CITY PLANNING COMMISSION

- APPLICATION:**
- A. Negative Declaration
 - B. Special Permit to allow the construction of a 16,992, sq. ft. warehouse/office building in the Light Industrial/Planned Unit Development (M-1)(S)-PUD) zone and Norwood Tech PUD.
 - C. Variance to allow for off-site parking and maneuvering on adjacent parcel.

LOCATION: Northeast corner of Research Drive and Opportunity Street

PROPOSAL: The applicant is requesting the necessary entitlements to construct a 12,748 sq. ft. warehouse with 4,244 sq. ft. of office use in the Norwood Tech PUD.

**EXHIBIT A
SITE PLAN**

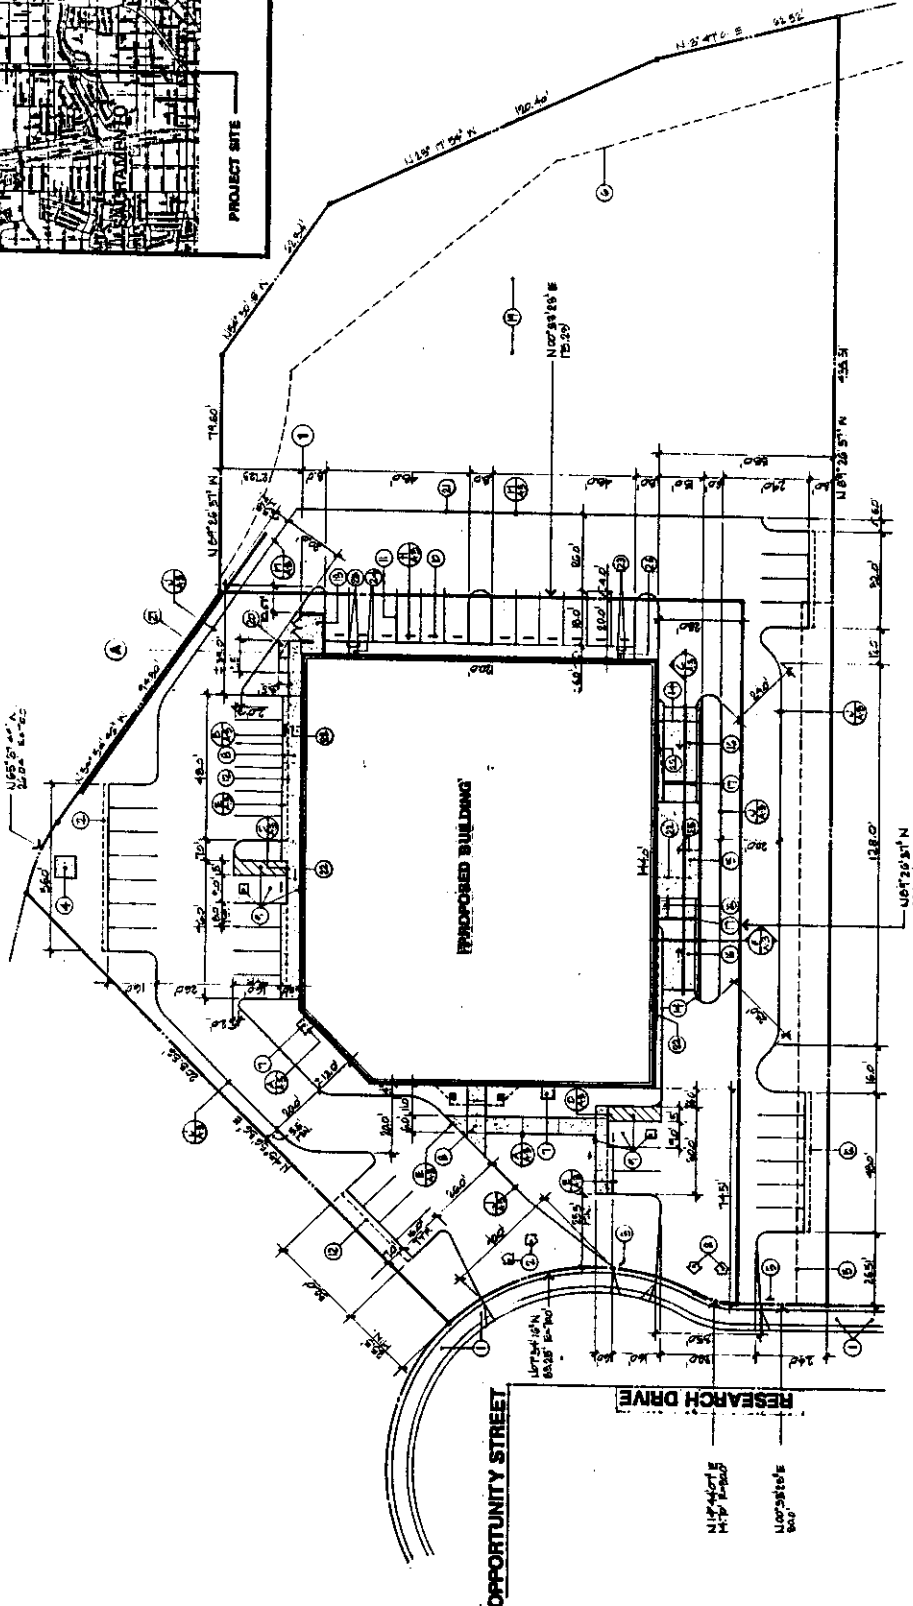
- Engineering
 1. Driveways are to close, combine access or remove one and redesign - 35 ft. maximum width;
 2. Reciprocal access easements required with adjacent parcels.
- Traffic Engineering
 1. Construct standard improvements consistent with existing improvements.
 2. Parking stalls to be 18 feet in depth.

3. North driveway will be radial to the elbow.
4. Maximum driveway width is 35 feet.
5. Obtain an reciprocal access easement to include an agreement which allows for parking, or
6. Merge lots or adjust lot lines, or
7. Lot line cannot split driveways.

6. The driveways shall meet the requirements of the Traffic Engineering Division.
7. The applicant shall submit a reciprocal parking and access agreement to the Planning Director prior to approval of final inspection of the structures by the Building Division.

**EXHIBIT B
 ELEVATIONS**

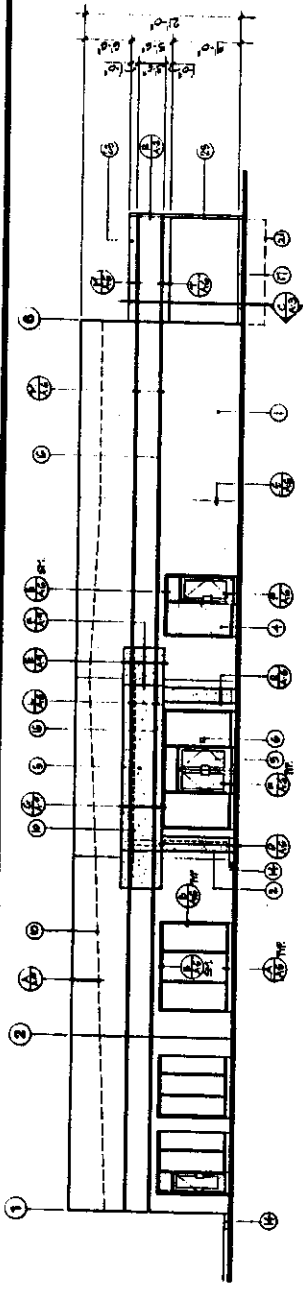
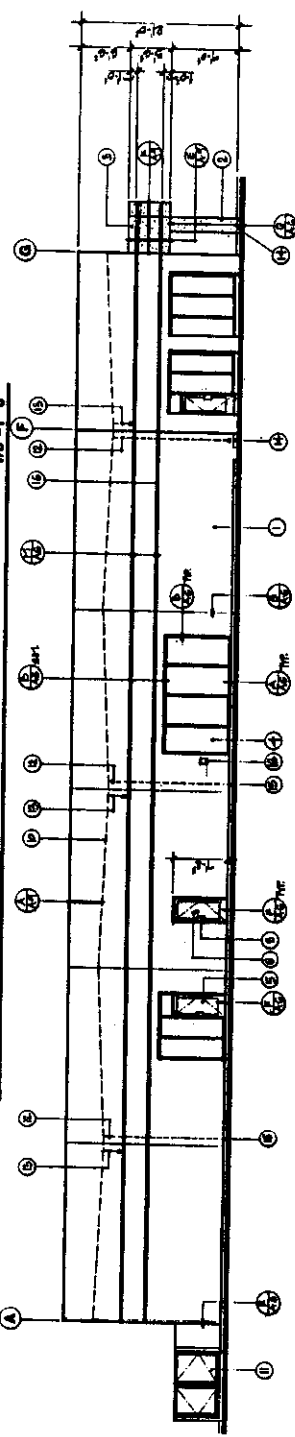
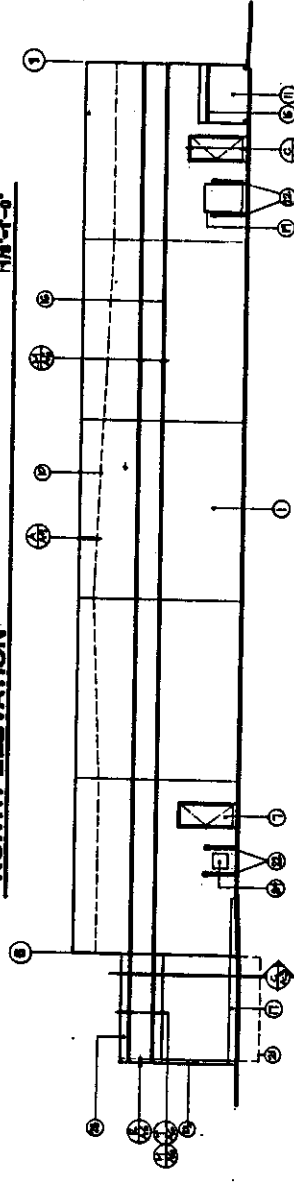
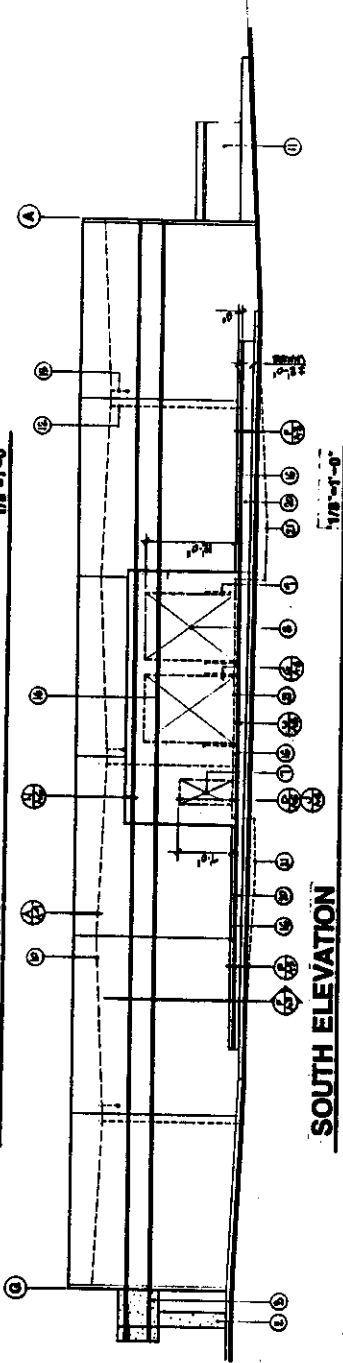
The project, as designed, does not meet the objective of the PUD, "to preserve and enhance the aesthetic values throughout the project."

The Design Review staff has reviewed the proposed elevations and has recommended the following modifications:

- **Amended by staff.*
- on the north, ~~east~~, and west elevations, a combination of brick veneer and concrete design should be utilized as ~~an~~ exterior finish materials. There should be a majority of brick. The brick can be used in either a horizontal or verticle design. A formliner should separate the brick from the concrete. The south and east elevations should be painted a color compatible with the brick. The use of reveal lines and This will greatly enhance the aesthetic quality of the building and will make the building more compatible with the adjacent buildings to the west and south. *formliner is recommended.*

- the projecting wing walls on the south side of the building should be extended in ~~length~~ to further screen the visual impacts of the loading area. *height*

- trash enclosure structure should meet the trash enclosure guidelines.
- Amended by staff.*

- Deleted by staff.* ~~all brick veneer shall be utilized on the north, east, and west elevations.~~
- Added by staff.* a. a combination of brick veneer and concrete design shall be utilized on the north and west elevations (with a majority of brick);

- Deleted by Staff*
- **Amended by staff* ~~Window openings shall be recessed along the north and west elevations; and~~
- b. The south and east elevations shall be painted a color compatible with the brick, utilizing reveal lines and formliners; and

- **Amended by Staff* c. the projecting wing walls on the south side of building screening the loading dock area shall be extended in ~~length~~ height.

EXHIBIT C
LANDSCAPING

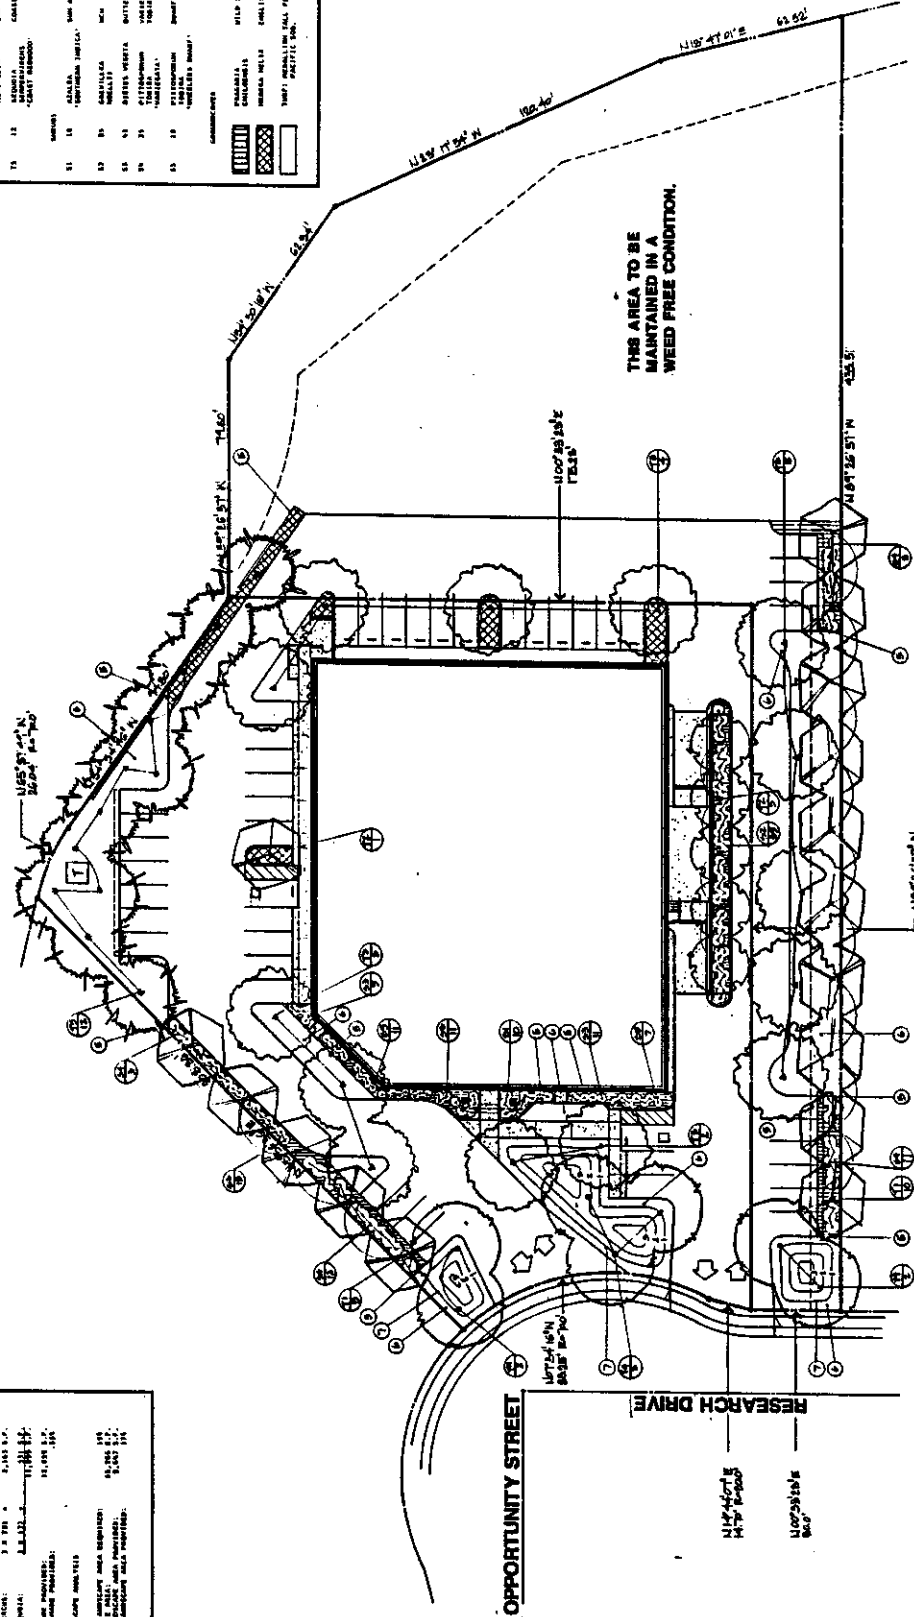
1. Landscaping: The submitted landscape plan indicates a 25.5 ft. front landscaped setback consisting of an undulating berm with turf and evergreen trees. Along the north property line, which is adjacent to the I-80 freeway off-ramp, a five foot planter is proposed. This planter will consist of ground cover and coastal redwoods planter at 25 ft. intervals along the entire northern perimeter. The southern property line is proposed to have an eight foot planter with ground cover and white alder trees at 25 foot intervals. A five foot planter with ground cover and trees is also proposed for the area just to the south of the loading dock area on the south side of the building. No landscaping is indicated on the landscaping plans for the east property line. Along this eastern side, the parking encroaches onto the adjacent parcel. Sod is proposed for a four foot planter between the parking area and the building. The undeveloped area to the east of the subject site should be maintained in a weed free condition.

landscaping is required on all interior property lines with a minimum of four feet on each property. Trees, equal in number to one tree per twenty-five lineal feet of each property line, shall be planted in the above defined areas in addition to required ground cover and shrub material. Staff finds that the submitted landscape plan meets all of the PUD requirements.

1. A minimum 15 percent landscape coverage shall be provided and other landscaping shall comply with the Norwood Tech PUD Guidelines.
2. A minimum 25 ft. building setback from both the street and freeway is required.
3. The undeveloped area to the east of the project shall be maintained in a weed free condition.
4. Trash enclosures shall meet the City's Trash Enclosure Guidelines.
5. Revised elevations shall be submitted to Planning Staff for review and approval prior to the issuance of a building permit. Modifications shall include:
